Economic Commission for Europe
Inland Transport Committee
World Forum for Harmonization of Vehicle Regulations
Working Party on Passive Safety
Sixty-fifth session

Geneva, 13–17 May 2019

**Report of the Working Party on Passive Safety on its
sixty-fifth session**
Contents

Figure A
SAE J211 sign convention

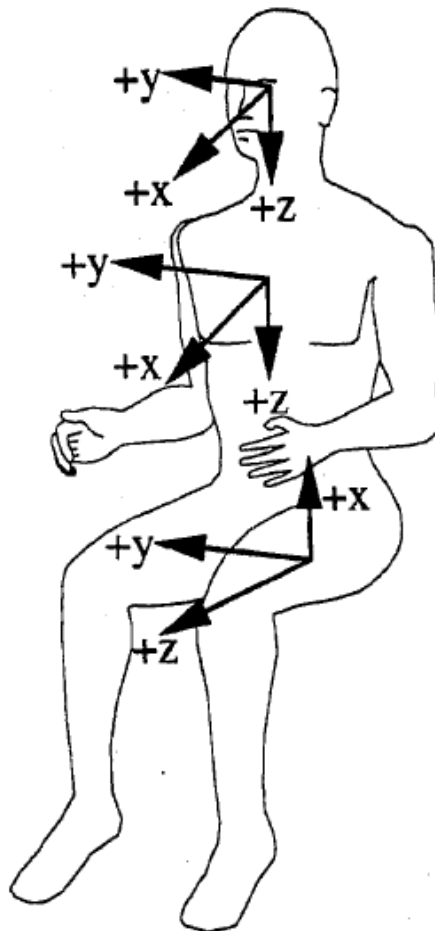
Amend paragraph 7.1.4.2.2. to read:

"7.1.4.2.2. The vertical component of the acceleration from the abdomen towards the head, "**-z**", when the measurement procedures defined in paragraph 8.5 of this document are followed, shall not exceed 30 g except during periods whose sum does not exceed 3 ms. The measurement procedures defined in paragraph 8.5 of this document follow those of ISO 6487 with SAE J211 sign convention, as shown in Figure A.

Figure 2
Ruler of measurement device

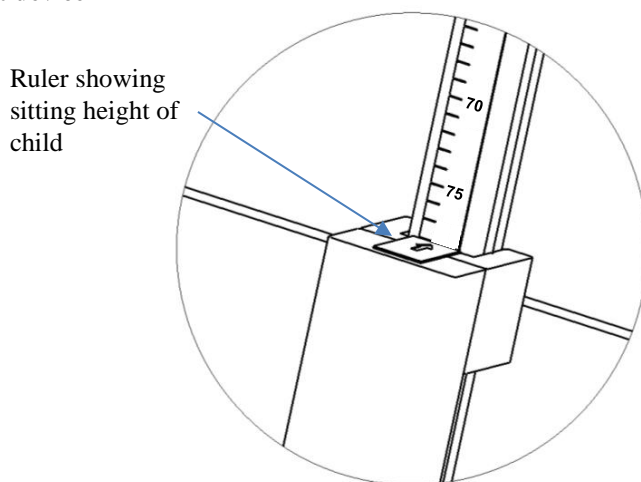
Insert new paragraph 6.1.3.6., to read:

"6.1.3.6. ...

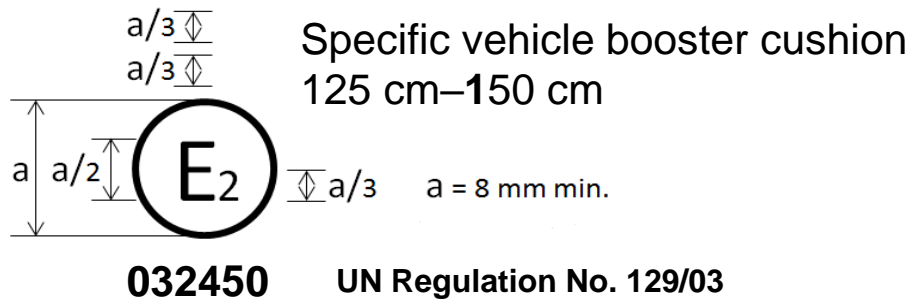
Annex 2, amend to read:

"Annex 2

1. Arrangements of the approval mark

Figure

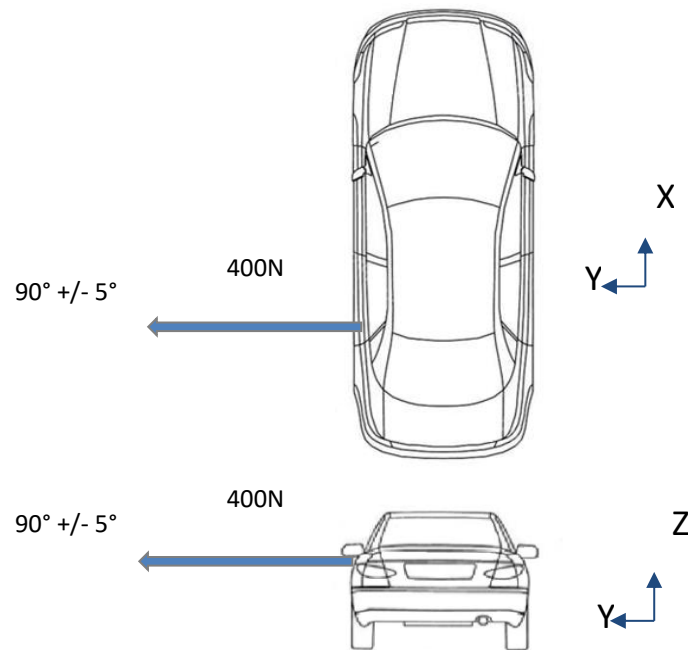
Paragraph 5.4.2.1, amend to read:

"5.4.2.1. The door shall remain latched;
